Drain: WINDERMERE DRAIN **Drain #:** 252
Improvement/Arm: WINDERMERE - SECTION 4B
Operator: JOH **Date:** 6-25-04
Drain Classification: Urban/Rural **Year Installed:** 1997

RE: Windemere Drain-Section 4B Arm

Re: Windemere Drain: 4b Arm

STORM SEWER PLAN & PROFILES WINDEMERE SECTION 4B

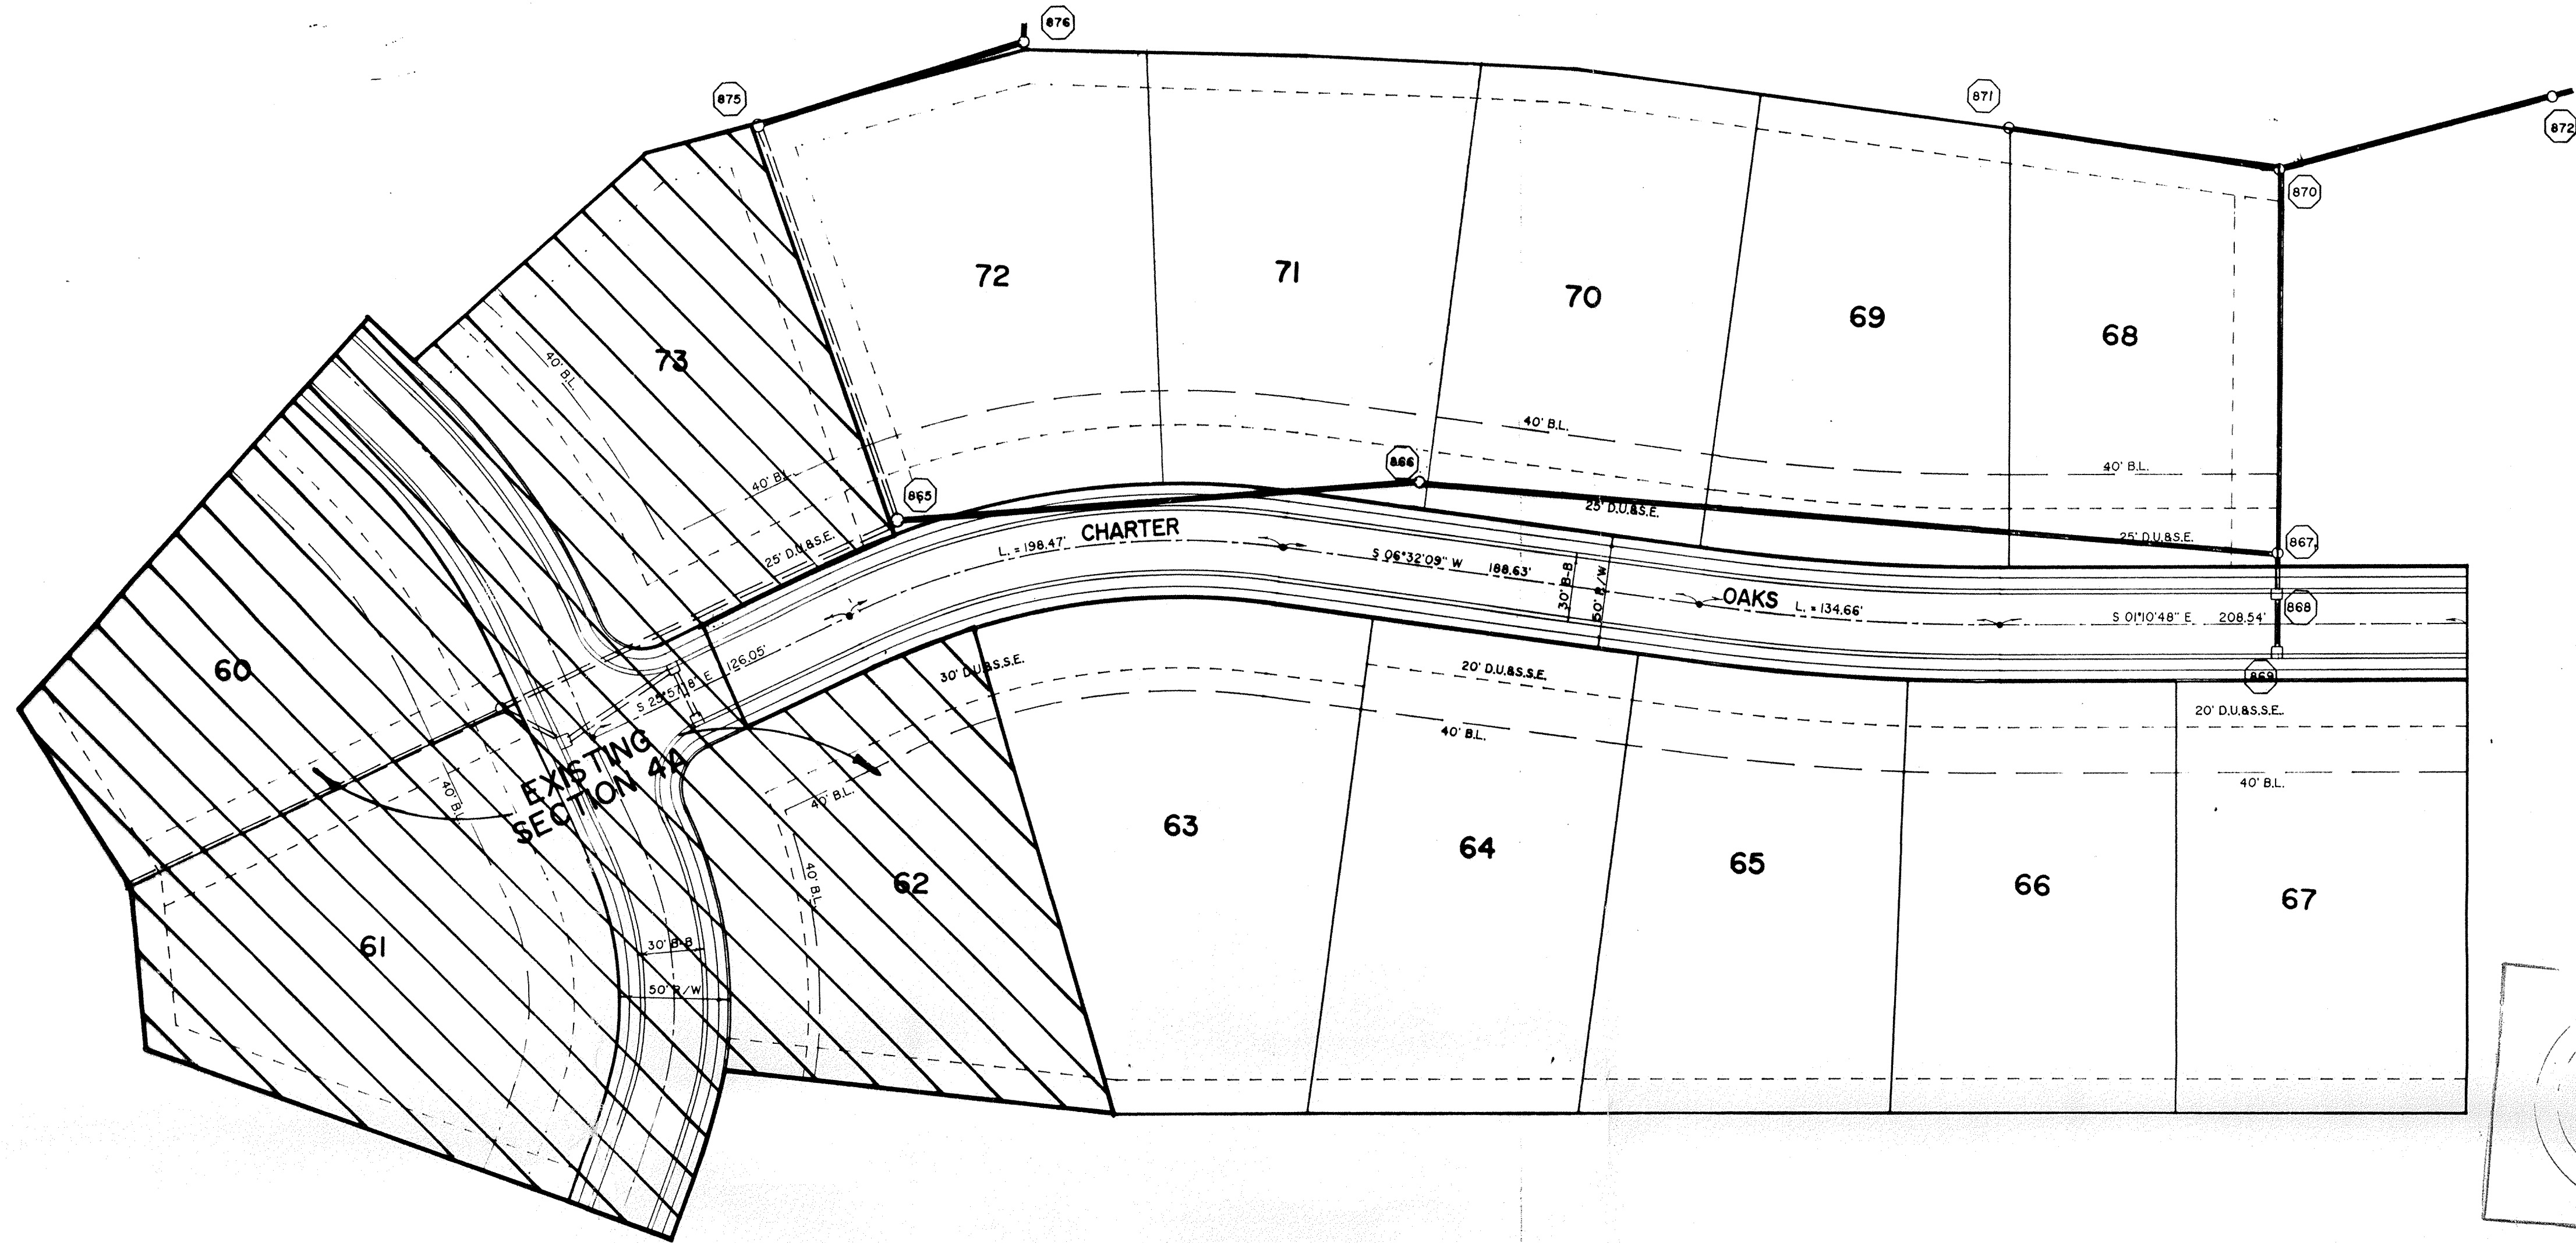
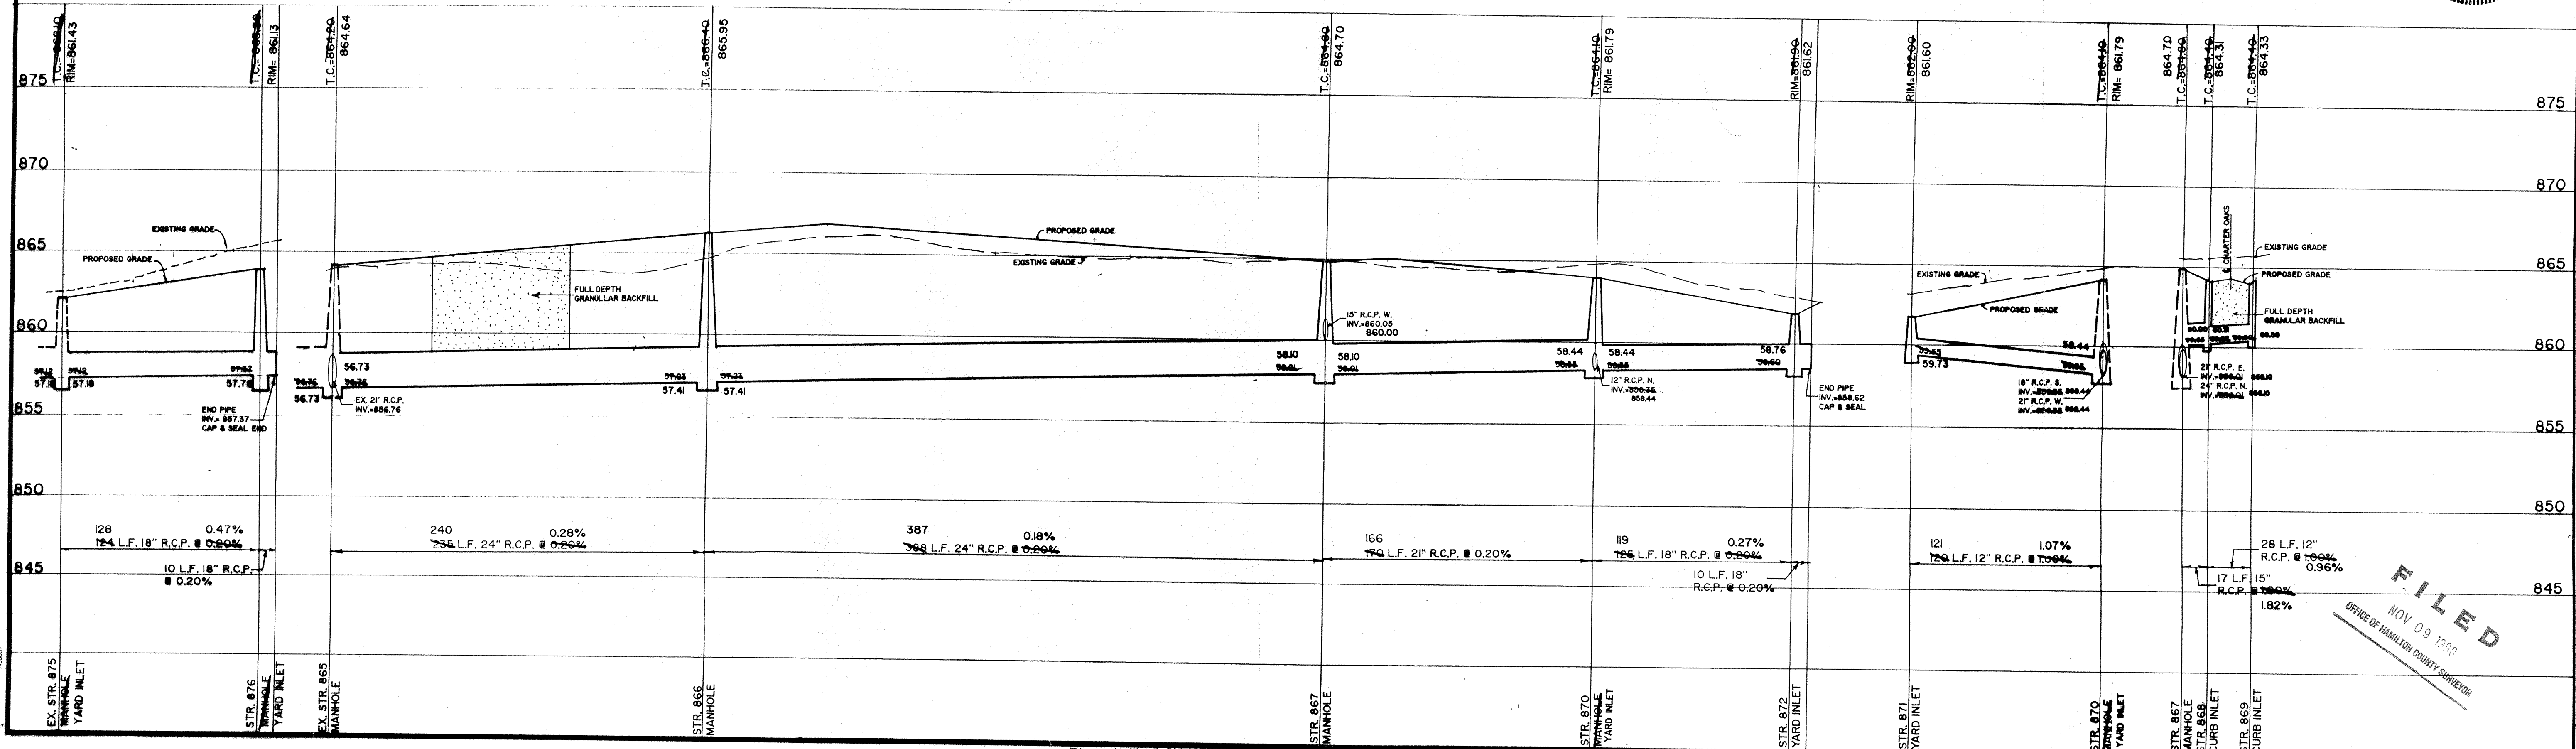
During construction, changes were made to the drain which will alter the plans submitted with my report for this drain dated May 6, 1997. The changes are as follows:

Structure: T.C.: I.E.: Pipe: Length: Original Plans: Difference:

869	864.33	860.56				
868	864.31	860.31	12	28		
868	864.31	860.31				
867	864.7	860	15	17		
870	861.79	858.44				
871	861.6	859.73	12	121	120	1
872	861.62	858.76				
870	861.79	858.44	18	119	125	-6
870	861.79	858.44				
867	864.7	858.1	21	166	170	-4
867	864.7	858.1				
866	865.95	857.41	24	387	388	-1
866	865.95	857.41				
865	864.64	856.73	24	240	235	5
876	861.13	857.76				
875	861.43	857.18	18	128	124	4

The length of the drain due to the changes described above is now **2,808 feet**.
